#### One-hundred-and-fifty-fifth session

### **Proposal for Supplement 3 to the 07 series of amendments to Regulation No. 14 (Safety-belt anchorages)**

#### **Submitted by the Working Party on Passive Safety \***

Figure 1b

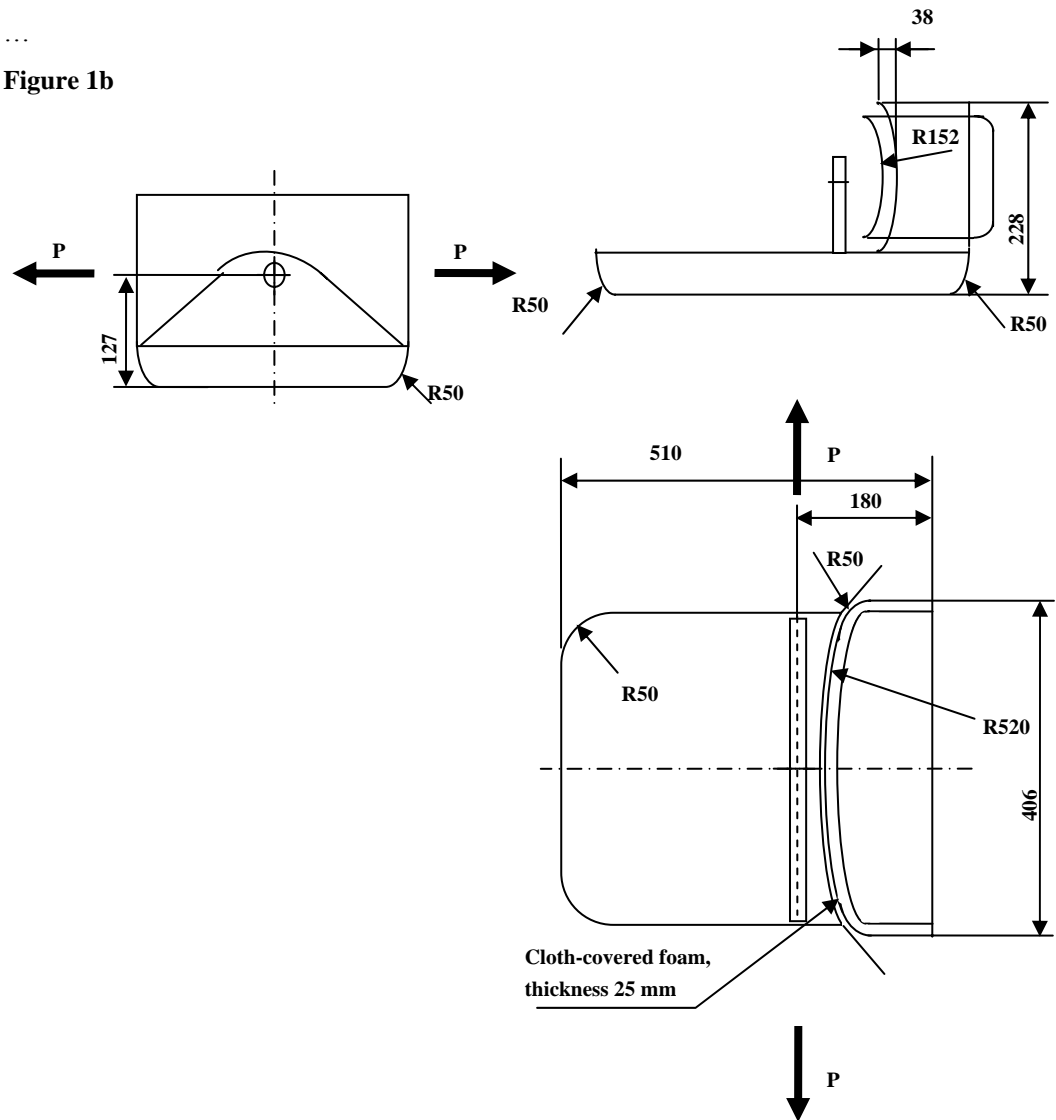
- 6.4.7.3. Traction device adapted for the test of side-facing seats is shown in Annex 5, figure 1b.
- 6.4.8. Test of the basic structure of side-facing seats

Annex 5, insert a new figure 1b, to read:
